Item Name: Crosstube Turning Detail

DART AEROSPACE LTD	Work Order:	89476
Description: Crosstube Assembly (205/212 Low Aft)	Part Number:	D212-664-247
Inspection Dwg: D212-664-247 Rev: B		Page 1 of 2

DRAWING NO. D212-664-247	TITLE CROSSTUBE ASS'Y (205 LOW AFT)	REV. B	DART AEROSPACE LTD ENGINEERING ORDER	D.E.O. NO. D212-664-247-B-1	SHEET NO. SHEET 1 OF 1	SCALE NTS
DRAWN <i>qd</i>	CHECKED <i>ASS</i>		MFG. APPR. <i>AB</i>	APPROVED <i>W</i>	DE APPR. <i>W</i>	
DATE 11.07.15	DATE 11.07.20		DATE 11.07.21	DATE 11.07.21	DATE 11.07.21

PURPOSE:
REPLACE MAGNOBOND WITH PROSEAL.

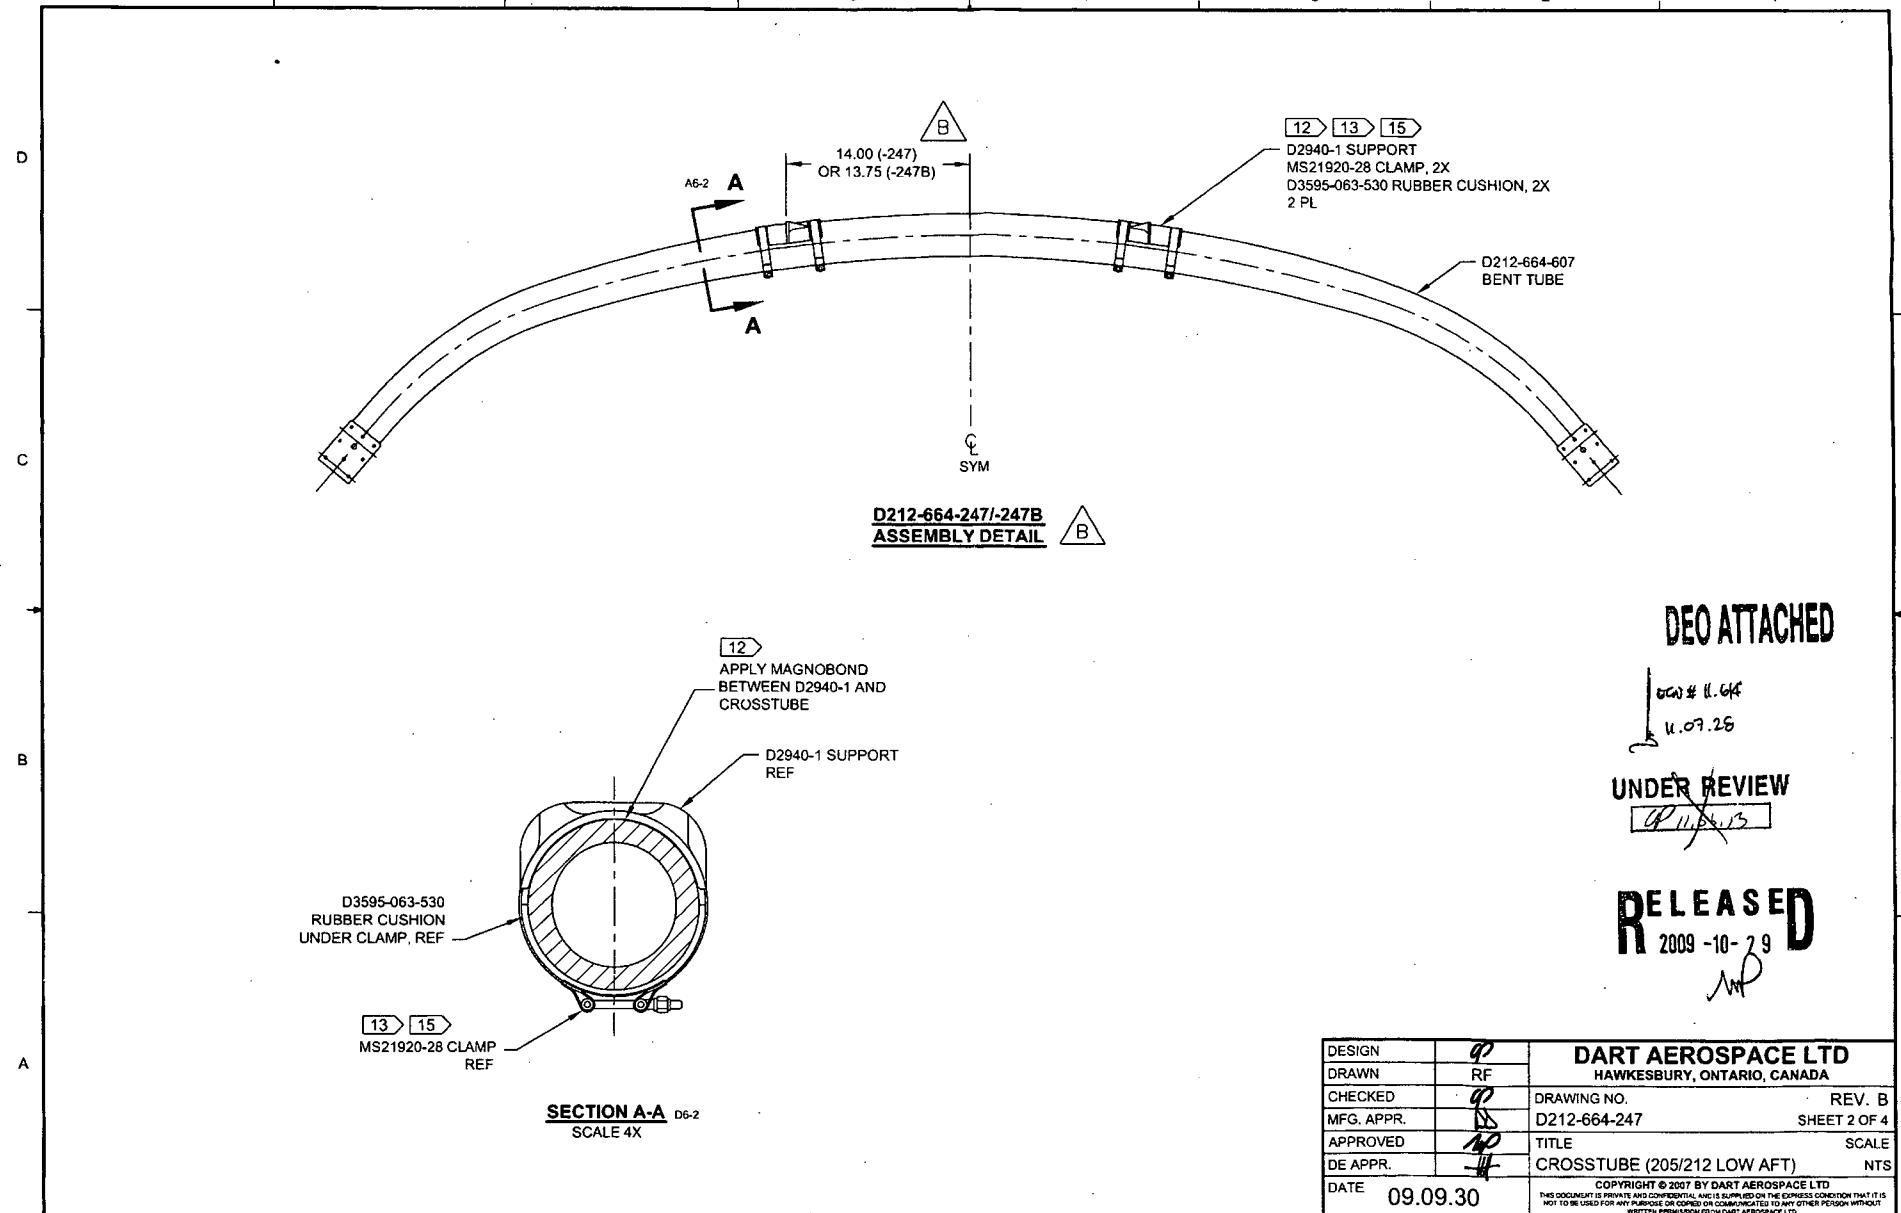
WAS:

9	A/R	A/R	MAGNOBOND 6398	ROCKWELL SPECIFICATION RBO-120-023 ADHESIVE (TEXTRON/BELL SPEC. 299-947-100, TYPE II, CLASS 2 ADHESIVE)
---	-----	-----	----------------	---

WAS:

- 12) INSTALL D2940-1 SUPPORT USING 0.03" TO 0.06" THICK LAYER OF MAGNOBOND 6398 TO THE SURFACE OF D2940-1 THAT WILL BE IN CONTACT WITH THE CROSSTUBE PER QSI 015. LET CURE FOR 12 HOURS AFTER INSTALLATION AND PRIOR TO PACKAGING.
- 15) TORQUE CLAMPS 80 TO 100 IN-LB. ENSURE AT LEAST 1.5 THREADS SHOWING IN SAFETY AND THAT NUT HAS NOT BOTTOMED-OUT AFTER TORQUING.

IS:

Item	Qty -247	Qty -247B	Part Number	Description
9	A/R	A/R	PROSEAL 890 B-2	SEALANT, AMS-S-8802 CLASS B-2

IS:

- 12) TO INSTALL D2940-1 SUPPORT: ABRADE MATING SURFACE OF SUPPORT AND CROSSTUBE WITH 180-GRIT SANDPAPER AND REMOVE RESIDUE WITH MEK (OR EQUIVALENT). APPLY A 0.04" TO 0.07" THICK LAYER OF PROSEAL 890 CLASS B-2 (OR AMS-S-8802 CLASS B-2) SEALANT TO MATING SURFACE OF SUPPORT.
- 15) TORQUE CLAMPS 80 TO 100 IN-LB. ENSURE AT LEAST 1.5 THREADS SHOWING IN SAFETY AND THAT NUT HAS NOT BOTTOMED-OUT AFTER TORQUING. PRIOR TO PACKAGING, RE-CHECK TORQUE ON CLAMPS AFTER PROSEAL 890 SEALANT HAS CURED FOR 72 HOURS.
